Part 4 -- Remarks

This Amendment and Response is responsive to the office action mailed November 2, 2004. A Petition for a Two-Month Extension of Time and the fee therefor is filed concurrently herewith, extending the time for response to April 2, 2005. April 2, 2005 is a Saturday, which extends the time for response to April 4, 2005.

Serial No. 10/628,859

FIG.2

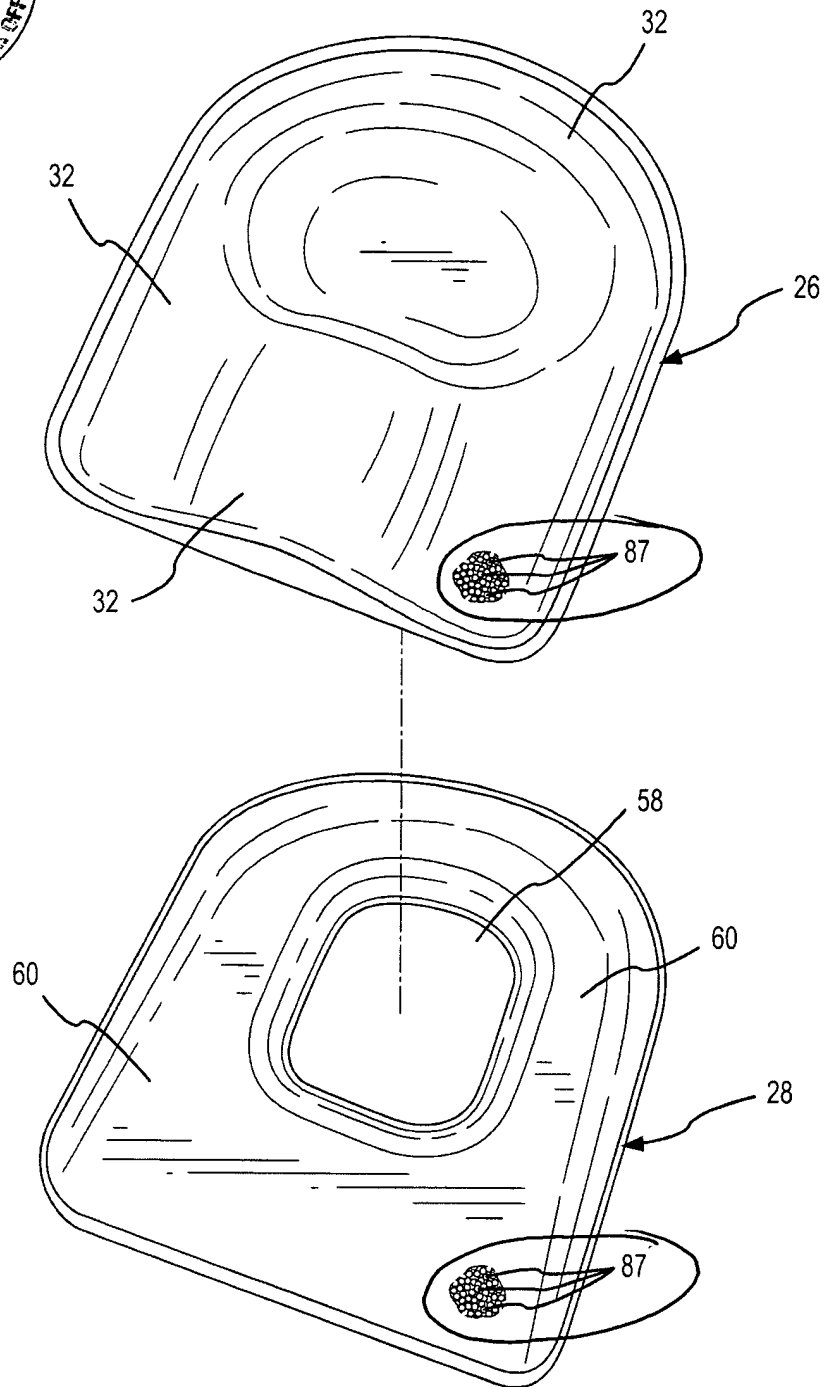
Figs. 2 and 3 have been amended to show the resilient plastic beads as previously described in the specification at page 18, line 18 to page 19, line 2. The additions to these figures are outlined in red ink attached at the end of these remarks. The replacement sheets 2 and 3 of drawings containing Figs. 2 and 3 have each been labeled "Replacement Sheet." It is believed that these corrections eliminate the basis for the objection to the drawings.

The paragraph at page 18, line 18 to page 19, line 2 have been amended to introduce the reference number 87 which refers to the plastic beads which are now shown in amended Figs. 2 and 3. No new matter has been added.

FIG.4

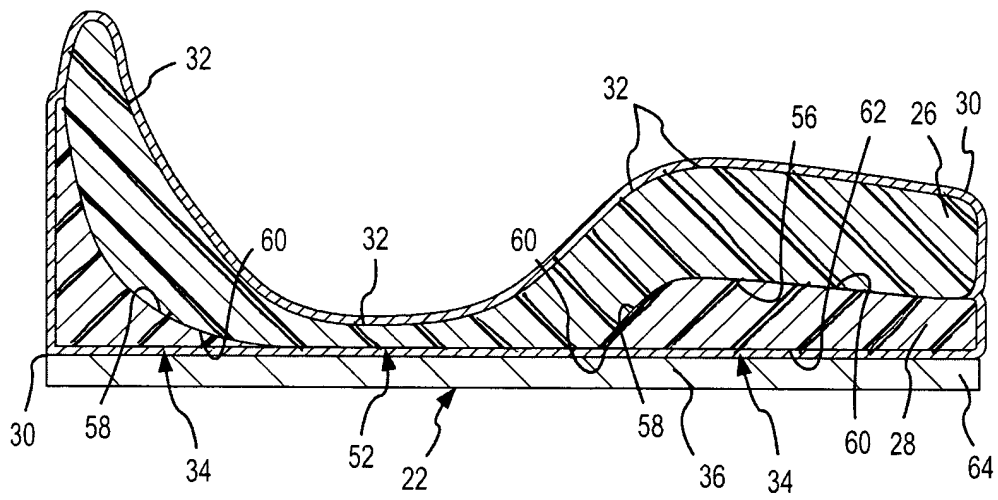
Fig. 4 has been amended by changing the characteristic of the crosshatching to illustrate the plastic nature of the materials used in constructing the human interface portion 26 and the base portion 28, as described in the preceding paragraph.
